COUNTY OF SANTA CRUZ

PLANNING DEPARTMENT

Application: 02-0432

**SUBJECT: Appeal of the Zoning Administrator's decision to approve
Application Number 02-0432**

Figure 2. Aerial view showing neighboring structures

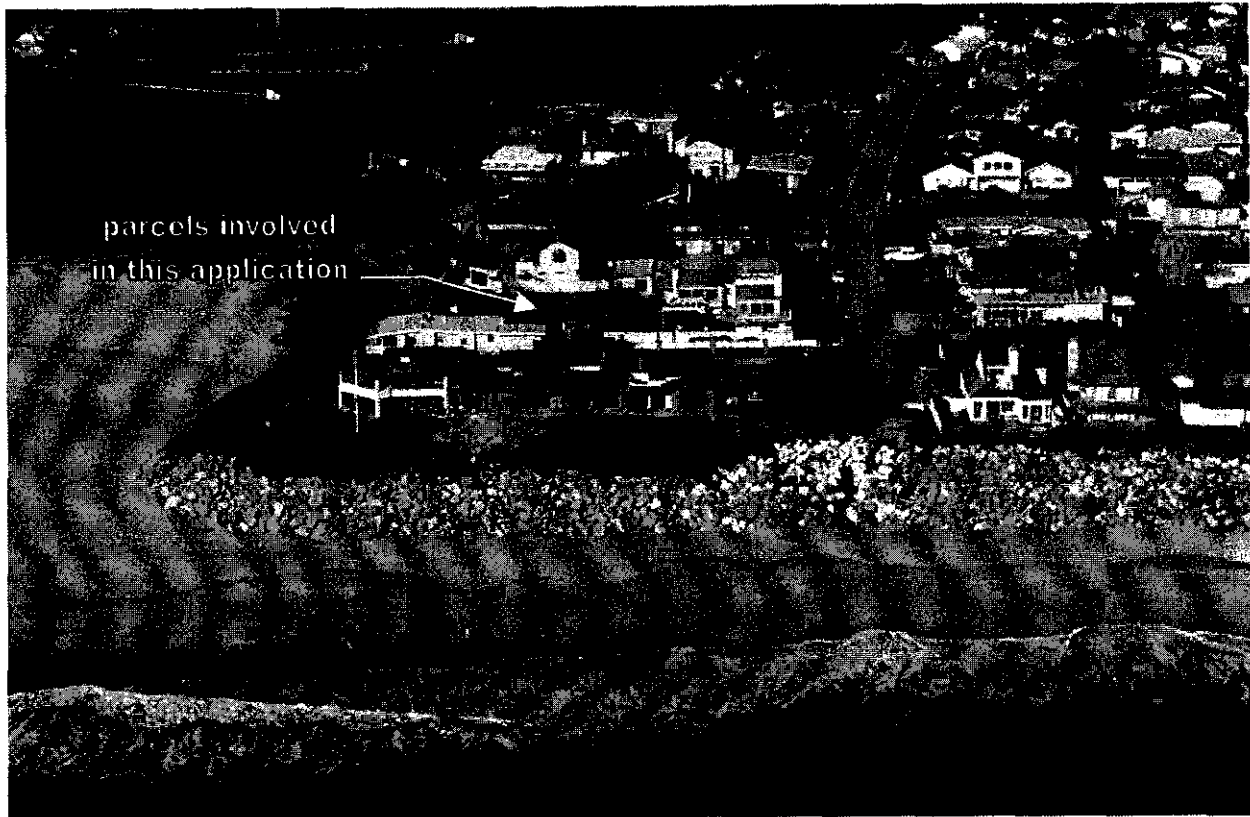
The appellant raises the issue that the proposed residence must be visually un-intrusive from the beach.

As discussed above, the proposed residence will be similar in design and *size* with the four existing residences on 23rd Avenue. This structure does not protrude beyond the existing houses on 23rd Avenue, meets the front, rear and side setbacks and is similar in design to the neighbors (*see* discussion below). Moving the house to the rear of the lot **will** have an insignificant effect **when** viewed from the beach.

Figure 3. Neighboring houses on 23rd Avenue

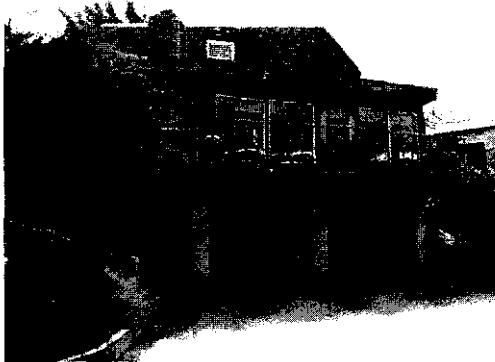
lot in the county with identical zoning. The “appearance” of three stories is very similar to that of the neighboring structures (which would argue **for** compatibility). See photos below.
